# Dauphin County Subdivision/Land Development Review Report

| Plat Title | Capital Region Water 1081 Elliot Street Land Development | | | | |

**Project Description**: The land development of an existing largely vacant industrial lot with new 14,732 SF industrial facility and associated site facilities.

EXISTING CONDITIONS PLAN

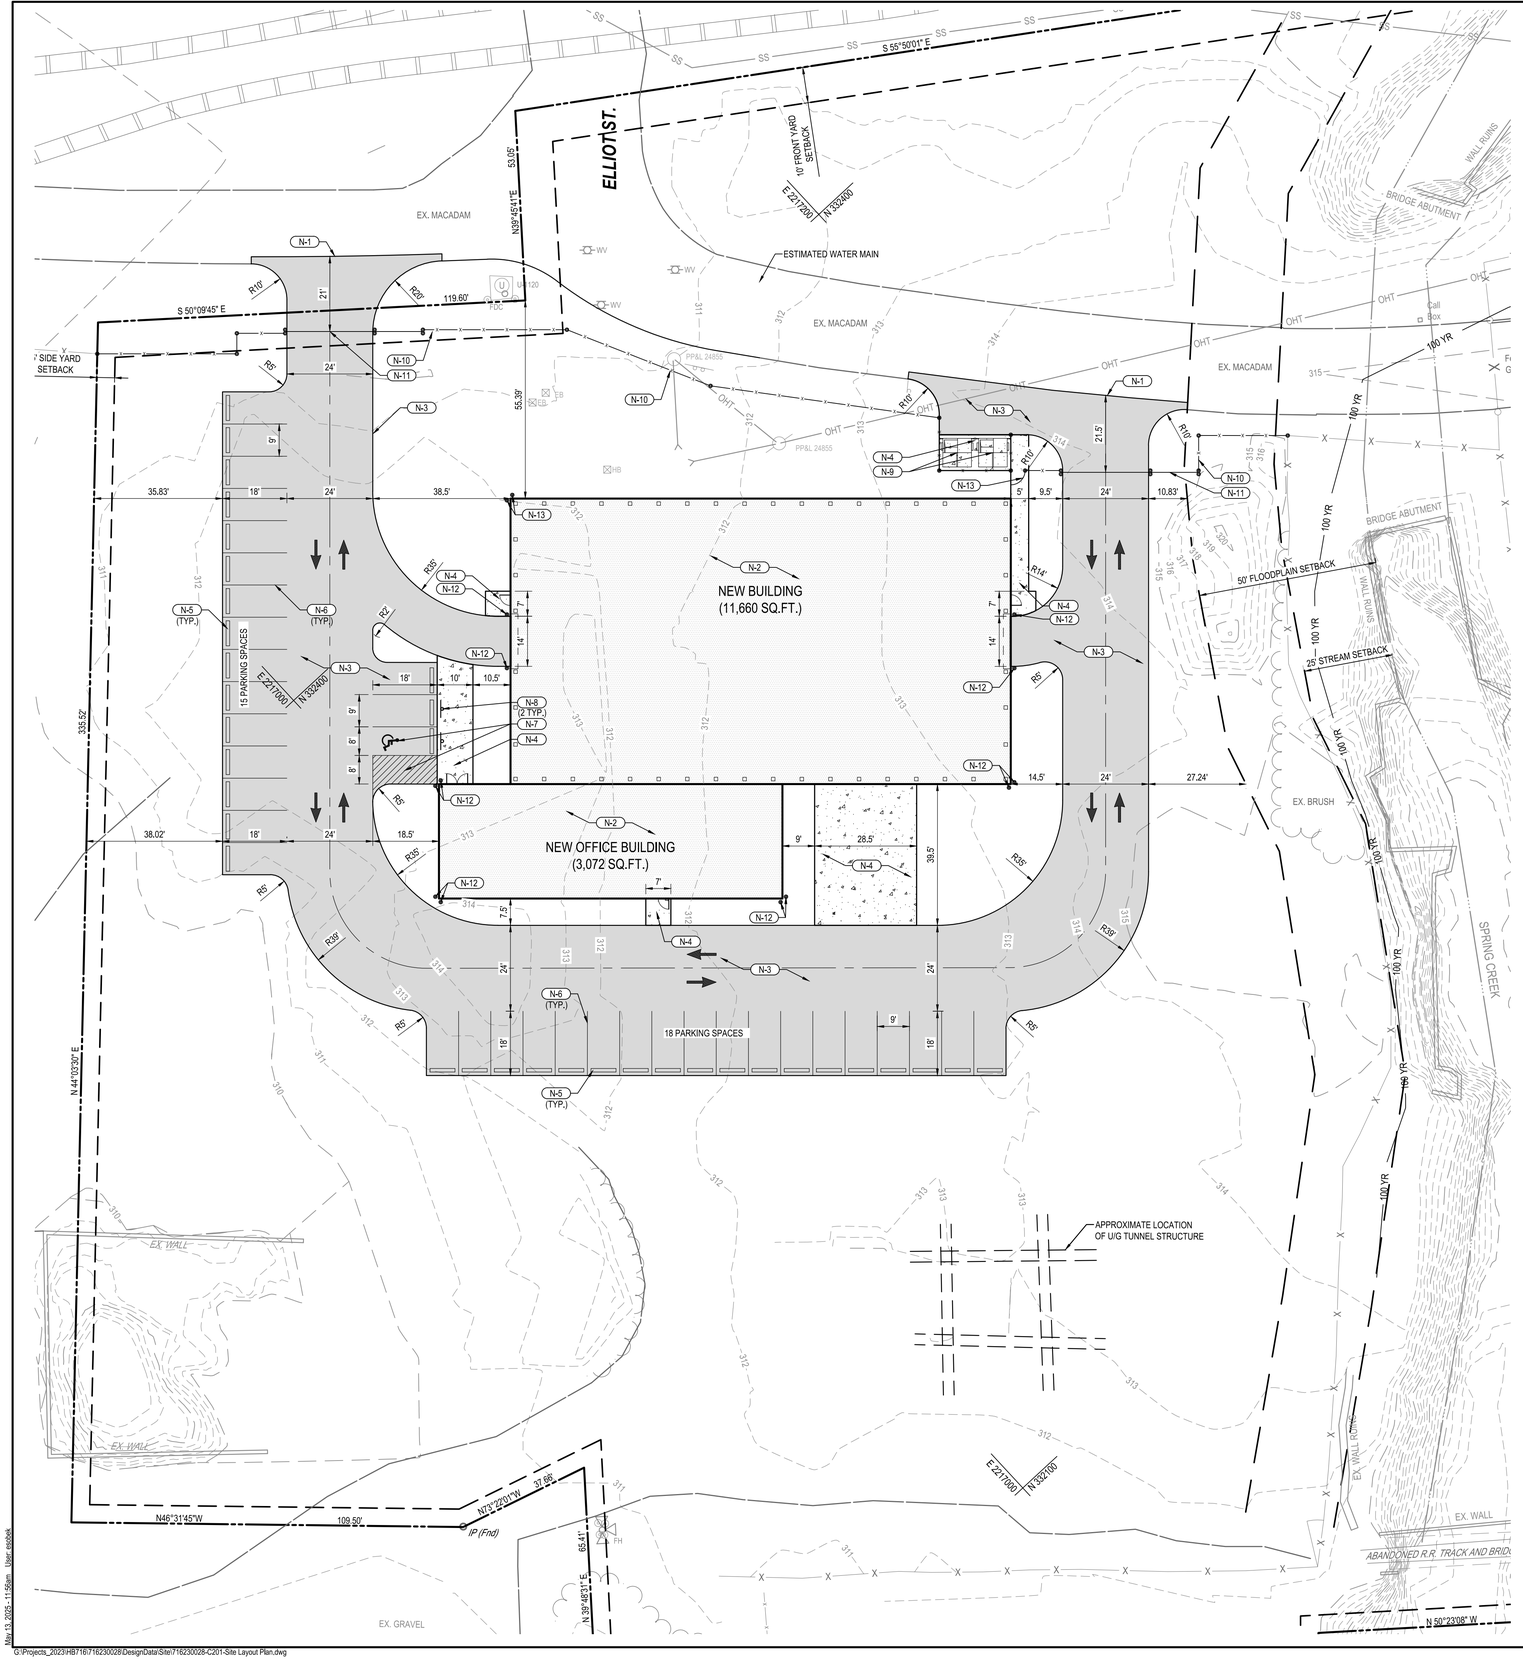
2. In addition, provided are some general observations:
   a. DCPC/TCRPC records indicate that the entire site lies within the 100-year floodplain. However, this condition does not appear to be clearly reflected on the submitted site plan. We recommend this be more prominently identified.

Entire property is not shown.

Note the right of way for Elliott Street. Is it a public street? If not is there an access easement?
